Subject: UniStar Nuclear Energy, NRC Docket No. 52-016
Response to Request for Additional Information for the
Calvert Cliffs Nuclear Power Plant, Unit 3,
RAI 103, Probable Maximum Surge and Seiche Flooding
Questions 02.04.05-2 and 02.04.05-4

**RAI No. 103; Probable Maximum Surge and Seiche Flooding,
Questions 02.04.05-2 and 02.04.05-4,**

Calvert Cliffs Nuclear Power Plant Unit 3

Figure 2.4-21—{SLOSH Chesapeake Bay Model Grid (SLOSH Basin cp2) and the Location of CCNPP Unit 3}

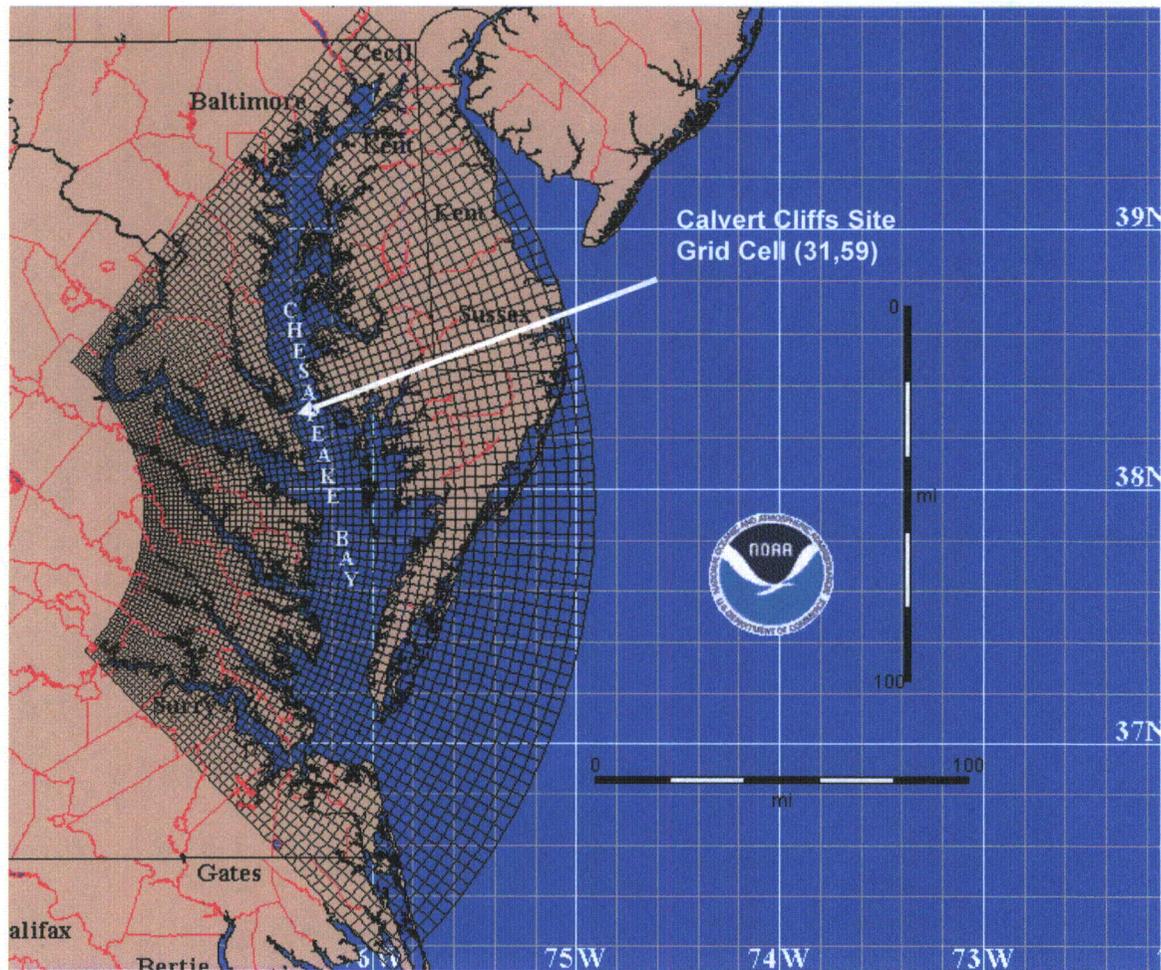
The NRC Staff's guidance states that recommendations of Regulatory Guide 1.59 should be supplemented by standard engineering practice currently in use. Please explain how the storm surge water surface elevations obtained from Regulatory Guide 1.59 and adjusted for CCNPP site location using the model developed for the Chesapeake Bay (USACE, 1959) are conservative with respect to current engineering practice described in USACE Engineering Manual 1110-2-1100 (USACE, 2006) and those of the NOAA National Weather Service with regard to the SLOSH model (NOAA, 1992), or justify an alternative approach.

The time sequence of hurricane movement or the hurricane track is a required input to the SLOSH model represented by a series of successive locations of the center of hurricane. The hurricane track is derived as a function of the hurricane direction (angle), forward speed, and landfall location (defined as the location where the hurricane crosses the shoreline). Model simulations are performed for different combinations of the PMH parameters to obtain the maximum surge water level at the site. The model results are processed using the NOAA SLOSH Display Program (NOAA, 2009). The CCNPP Unit 3 is located in the SLOSH model grid cell (31, 59) and the simulated time histories of water levels are extracted from this grid cell for the PMSS evaluation. The model grid for the Chesapeake Bay basin and the location of CCNPP Unit 3 site are shown in Figure 2.4-21.

Figure 2.4-22—{Selected PMH Track and the Envelope of Resulting Surge Elevation in the SLOSH Chesapeake Bay Basin for the PMH}

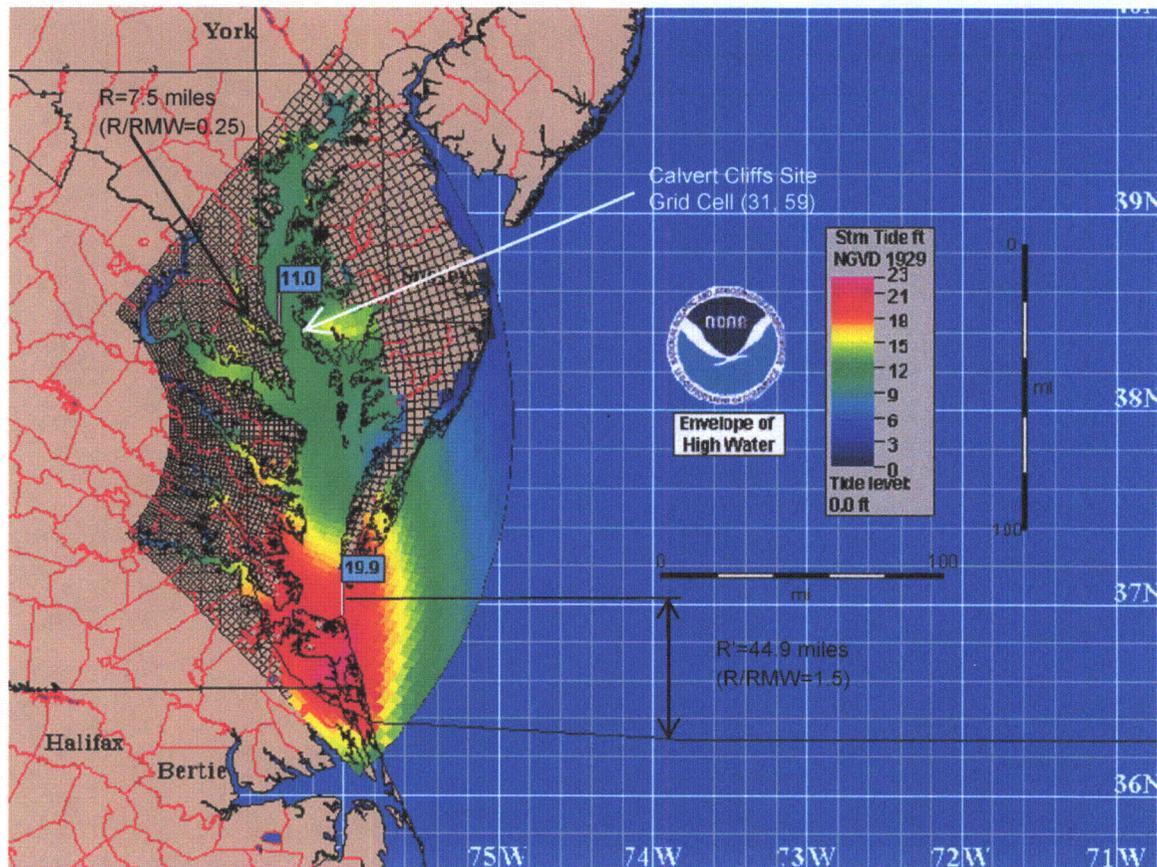
Please provide a set of alternate locations of the eye of the Probable Maximum Hurricane storm (FSAR Figure 2.4-26) to demonstrate that the chosen location would maximize the overwater fetch and therefore result in the most severe plausible storm surge near the CCNPP site.

Based upon the above studies a PMH track was developed. The selected PMH track direction and the envelope of simulated maximum surge elevation for the SLOSH Chesapeake Bay basin is shown on Figure 2.4-22. The PMH parameters (e.g., Radius of Maximum Winds and Central Pressure) were computed for 16 points (1 hour intervals) along the PMH track. This information is provided in Table 2.4-23 and is used to compute surge height using the SLOSH model.

The Probable Maximum Hurricane (PMH) will cause the highest surge height at the CCNPP Unit 3 site when it travels north following a track on the west side of the Chesapeake Bay. The SLOSH simulation results show that the highest sustained wind speed of a PMH to generate the maximum wave height at the CCNPP Unit 3 site will come from the east or southeast and will occur when the eye of the hurricane is southwest of the CCNPP Unit 3 site at a distance equal the radius of maximum wind. The selected PMH track is provided in new FSAR Table 2.4-23 and shown on new FSAR Figure 2.4-22.
